**SERVICE BULLETIN**

92

**TITLE INSPECTION AND RECTIFICATION OF FUEL VENT AND HYDRAULIC RESERVOIR TUBE, PLUS VENT PIPE INLET RE-ORIENTATION****CLASSIFICATION****SAL have classified this Service Bulletin as Highly Recommended****COMPLIANCE At or before next 50 hr check****APPLICABILITY:**

T67M260-T3A. Works No. 2109. 2110, 2123 to 2128, 2130 to 2158, 2160 to 2233.

FIG 1  
WING FUEL TANK VENT (MOD M701)

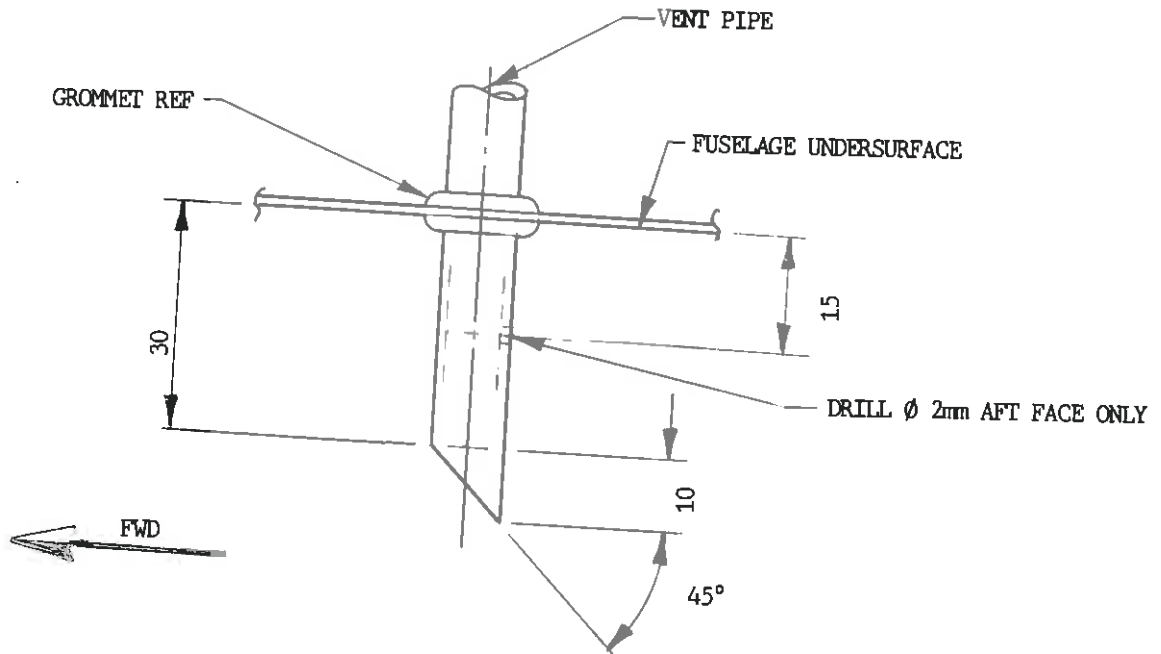
1. Inspect the fuel tank vent pipes below the centre section.
  - i) If the vent pipes are found to be stiff and hard, replace.
  - ii) If the vent pipes do not appear to have a yellow cast to them, replace.
  - iii) If in doubt, replace.
2. During inspection or during course of replacement, re-fit vent tubes with opening facing forward. Drill 2mm hole in aft face. Ref Fig. 1.

This action invokes modification M701. Annotate in aircraft logbook "Mod M701 incorporated".
